# Access Compliance Report

## Public Rights-of-Way

Intersection ID: 45167	Main Street: ARAGORN_LN	Cross Street: STRIDER_DR	Location: S
ADA ID: A2B0A54559D3	Ramp Type: BlendTrans1	Initial Pass/Fail: Fail	Overall Compliance: No
Severity Score: 8.75			
Codes/Mitigation Info/Possible Solution		Field Measurements/Component Compliance

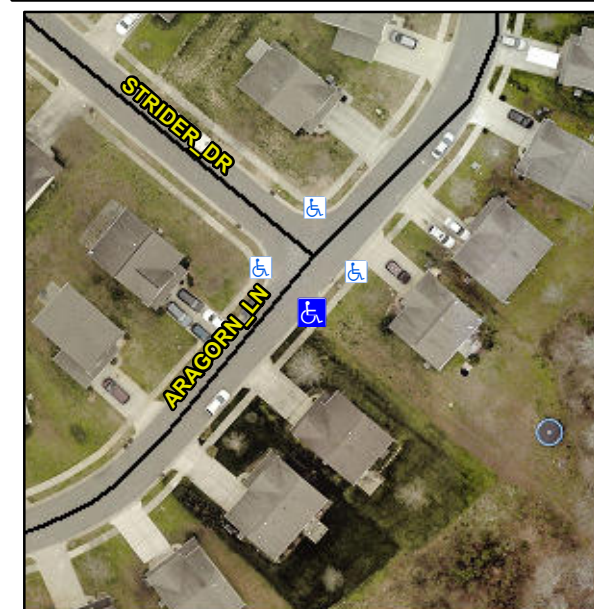
**Remove & Replace Curb Ramp With Two New Directional Ramps or Equivalent.**

**R304.5.1**

Compliance	Description	Data	Compliance	Description	Data
N/A	Ramp Length (in)	48.0	Yes	BlendTrans Slope (%)	3.5
No	Ramp Width (in)	41.5	Yes	BlendTrans XSlope (%)	0.1
N/A	Flare Type LT	N/A	N/A	Flare Type RT	N/A
N/A	Flare Slope LT (%)	N/A	N/A	Flare Slope RT (%)	N/A
N/A	Flare Traversable LT?	N/A	N/A	Flare Traversable RT?	N/A
N/A	Landing Length (in)	N/A	N/A	DWS Provided?	N/A
N/A	Landing Width (in)	N/A	N/A	DWS Contrast?	N/A
N/A	Landing Slope (%)	N/A	N/A	DWS Length (in)	N/A
N/A	Landing X Slope (%)	N/A	N/A	DWS Full Width?	N/A
N/A	Landing Curb? (Y/N)	N/A	N/A	DWS Offset (in)	N/A
N/A	Shared Landing?	N/A			
N/A	Gutter Ponding?	N/A	N/A	Gutter Slope (%)	N/A
N/A	Gutter Lip Ht (in)	N/A	N/A	Gutter X Slope (%)	N/A
N/A	Painted X Walk1?	No	N/A	Painted X Walk2?	N/A
	X Walk 1 Direction	To NW		X Walk 2 Direction	N/A
	X Walk 1 Width (in)	N/A		X Walk 2 Width (in)	N/A
	X Walk 1 Slope (%)	3.0		X Walk 2 Slope (%)	N/A
	X Walk 1 X Slope (%)	0.2		X Walk 2 X Slope (%)	N/A
